2.0 Technical Specialist Memo – Development Engineering

- *Substantive Application for The Point Mission Bay to Construct and Operate a Comprehensive Retirement Village (Integrated Residential Development) on the Site at 217 Kupe Street, 106 Rukutai Street, 95 Aotea Street, Rukutai Recreation Reserve, and Aotea Street Recreation Reserve, Orakei, Auckland (AEE) by Bentley & Co dated 11/2025*

6.0 Specialist Assessment

Figure: Adopted SMP Information (Source: GeoMaps)

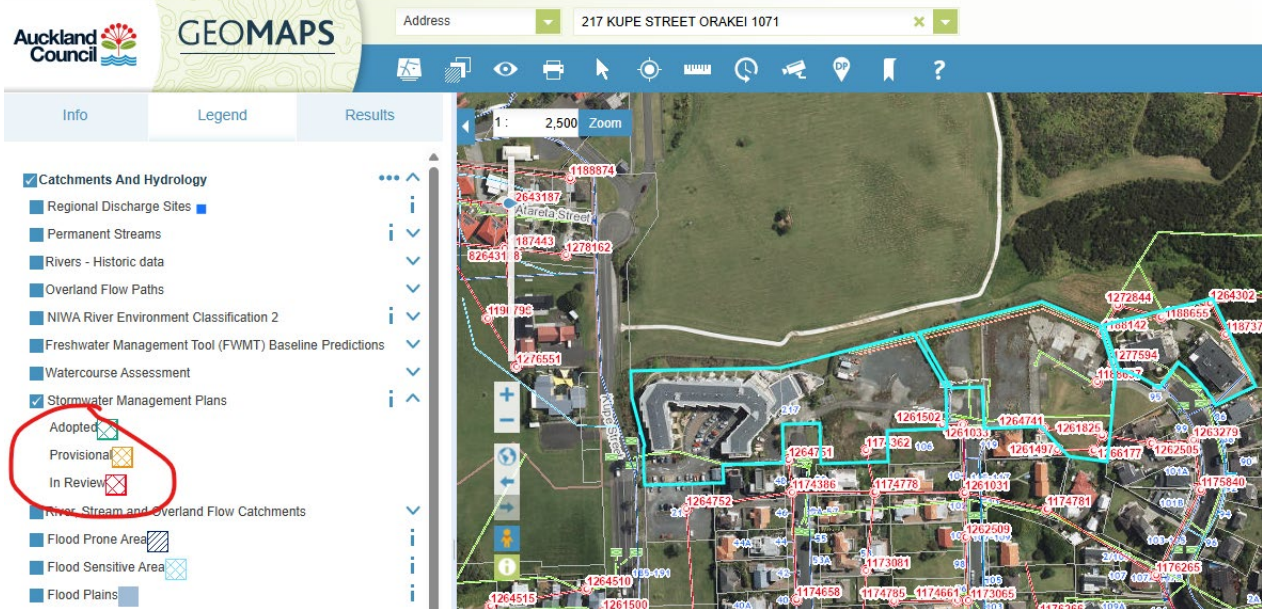
Auckland Council's GeoMaps shows that currently there is no adopted SMP for the subject sites and adjoining areas. According to the application report, I understand that HW was involved in the pre-app review and requested a SMP. However, no SMP has been provided. Instead, information addressing the SMP required components has been presented across application reports.

Given that there is no adopted SMP, I advised during the S92 process that the applicant needs to prepare an SMP covering **catchment, water quality, stream hydrology, and flooding** in accordance with the NDC

Figure: Flooding information Shown on GeoMaps

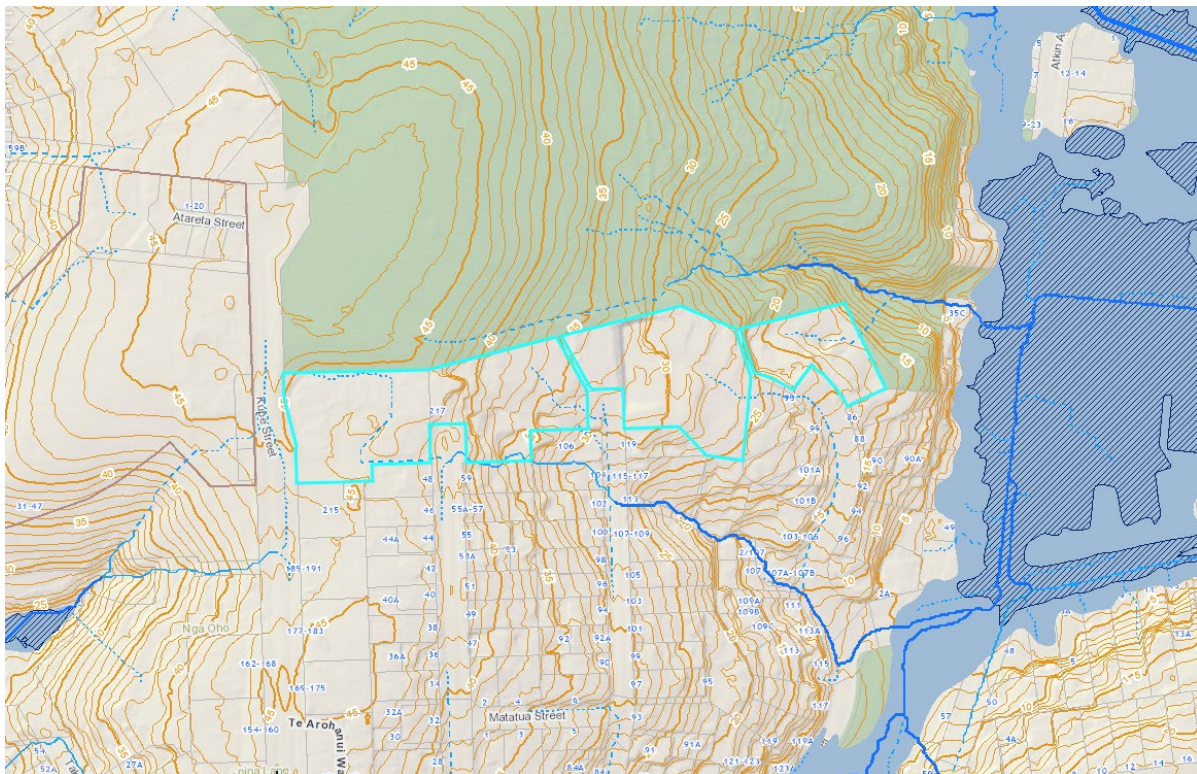
According to the Council’s GeoMaps information available on 17/03/2026, there are a number of overland flow paths (OLFP) initiating from the site and flowing towards southeast and northeast, respectively.

Figure: Modelled 1% AEP Floodwater Extents showing pre and post development conditions (Source: Application Report)

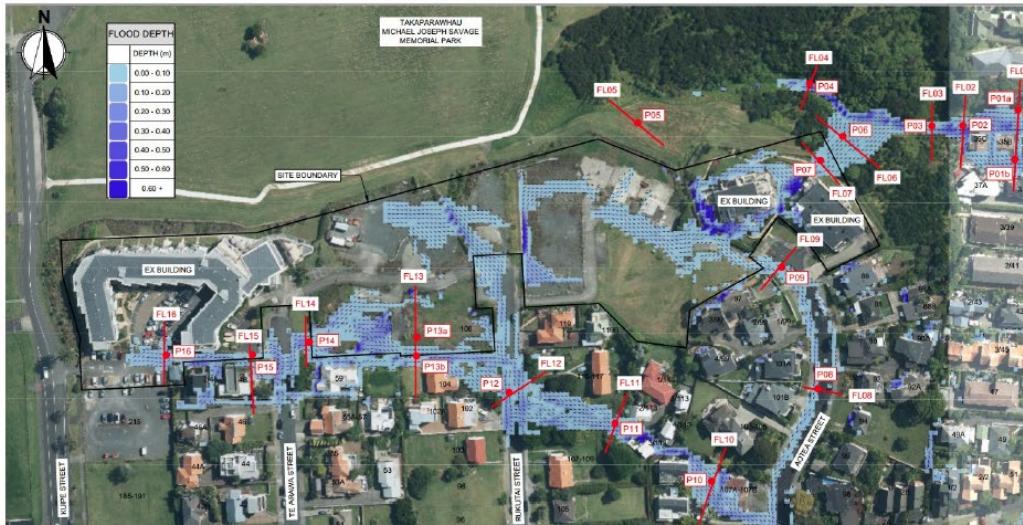
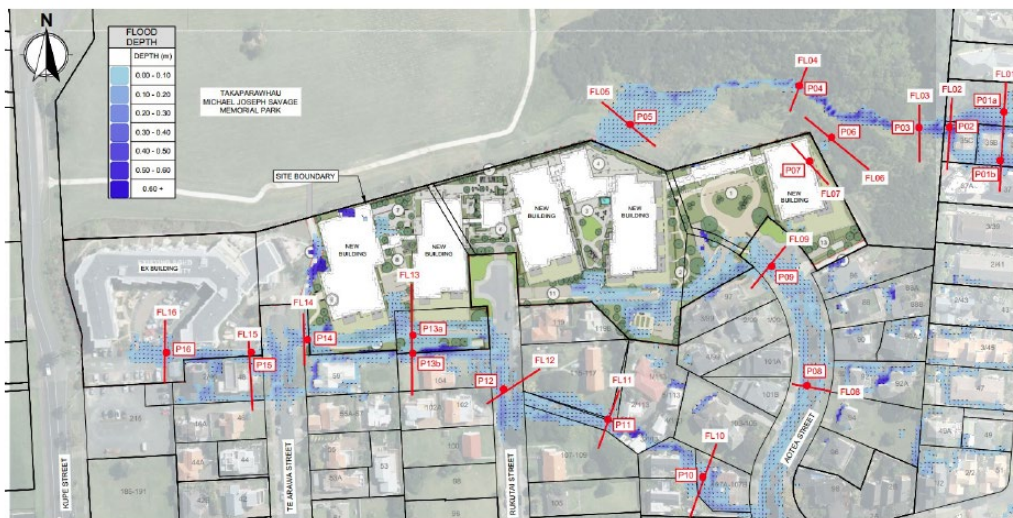
The 1% AEP floodwater extent plans contained in the report for the pre and post development conditions indicate that the alignment and exit of the OLPFs will remain largely unchanged from the existing condition.

It is noted that the identified increase in flow post-development at Node B is minor and occurs within the road reserve of Aotea Street, therefore, I have no concern. Regarding the increase at Node C, concerns about the potential effects on downstream properties were raised during the S92 process, together with a couple of other queries as a result of my review of the modelling study findings and associated assessment. These are outlined in italics below.

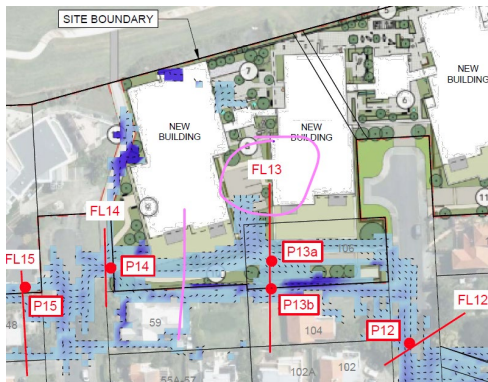
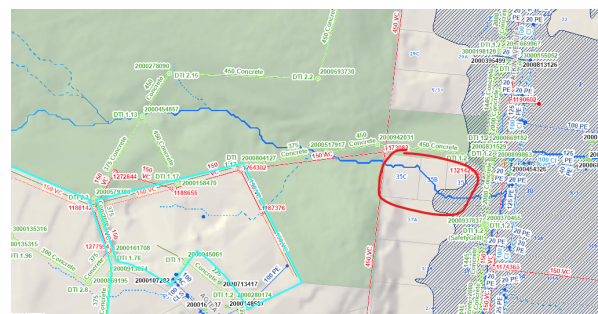
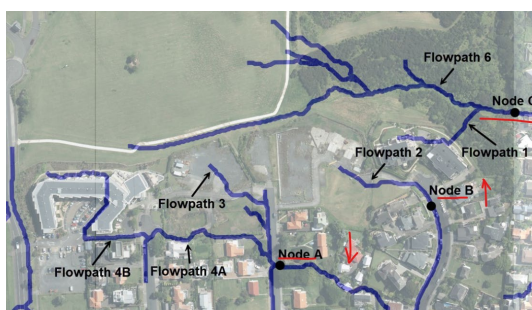
- The earthwork plan indicates that fill within the subject sites to the south of Buildings 4 and 5, please provide the cross-section plan annotated as FL13, and a new cross section as per my markup below to demonstrate that the OLFP will retain within the sites.

- For the identified post-development flow increase at Node C and its potential effects on downstream properties particularly those right on the OLFP, please advise whether any mitigation measures have been considered.

- *If there are any entrances at the locations of Building 5 where the modelling results indicate floodwater ponding during major storm events, please provide a cross section incorporating the profile of the adjacent entrances and label the 1% AEP floodwater level and adjacent FFLs.*
